# Wisconsin Department of Transportation

**Proposal #36: 9509-00-70**  
**T Plum Lake, CTH N**  
**Plum Creek Bridge B-63-0030**  
**CTH N**  
**Vilas County**

This is Addendum No. 01, which provides for the following:

Addendum No. 01  
ID 9509-00-70  
Revised Sheet 70  
December 9, 2021

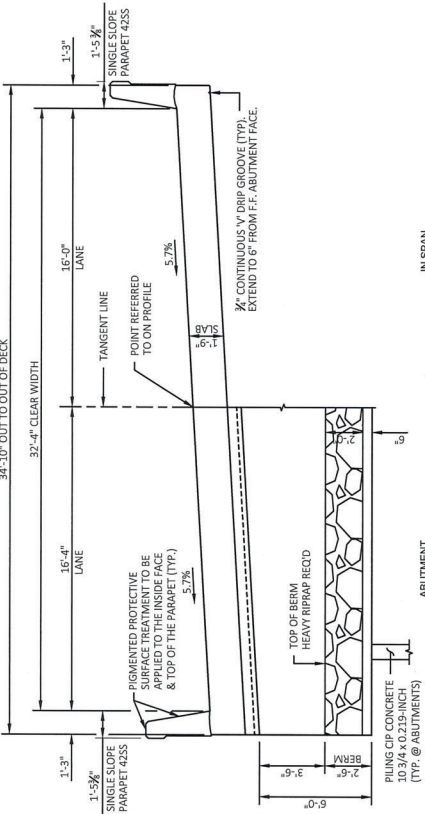
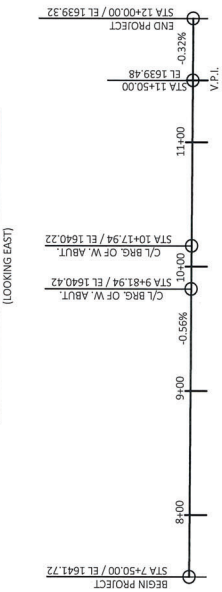
Revised Plan Sheets	
Plan Sheet	Plan Sheet Title (brief description of changes to sheet)
70	Total Estimated Quantities (W. Abut. to 9, E. Abut. to 9 for a total of 18 pile points.)

505.0600	BAR STEEL REINFORCEMENT HS COATED STRUCTURES	SY	10	10	-	20
516.0500	RUBBERIZED MEMBRANE WATERPROOFING	EACH	9	9	-	18
550.0500	PILE POINTS	LF	675	810	-	1485
